Development Review Board Meeting Memorandum

Topic: Andante Law Group (47-DR-2016)

DEVELOPMENT REVIEW BOARD REPORT

Andante Law Group
47-DR-2016

MECHANICAL SCREENING EXHIBIT

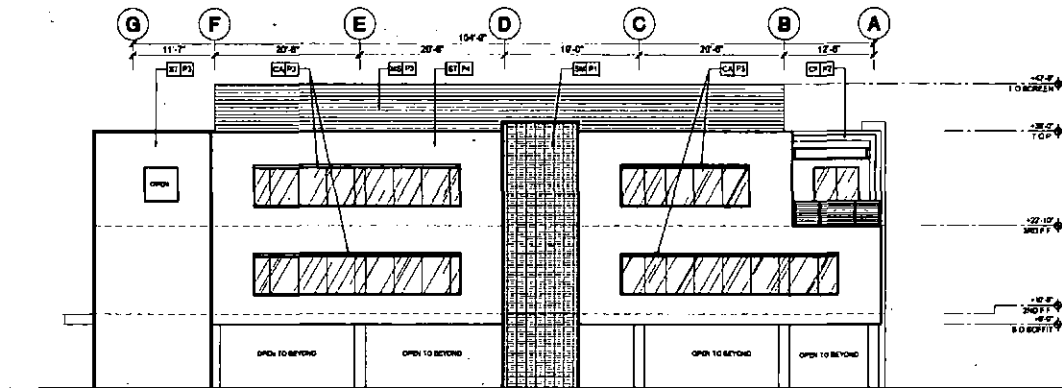
Action Requested: To include a stipulation regarding mechanical equipment screening material in the Development Review Board a motion

With final plans submittal, the applicant shall modify the roof-top mechanical equipment screening to be flat metal panels that have a 12-18 inch width and have a similar finish as the other metal work that is utilized elsewhere on the building.

2. At time of final plans, the applicant shall revise the metal roof-top mechanical equipment screening to an open louver design.
3. At time of final plans, the applicant shall revise the blue and clear glass to a reflective value that reduces the mirrored affect. Glass reflection and glazing is subject to the satisfaction of city staff.
4. At time of final plans, the applicant shall revise the gray paint color "Storm Cloud" to a paint color that incorporates warm earth tones. Paint color is subject to the satisfaction of city staff.
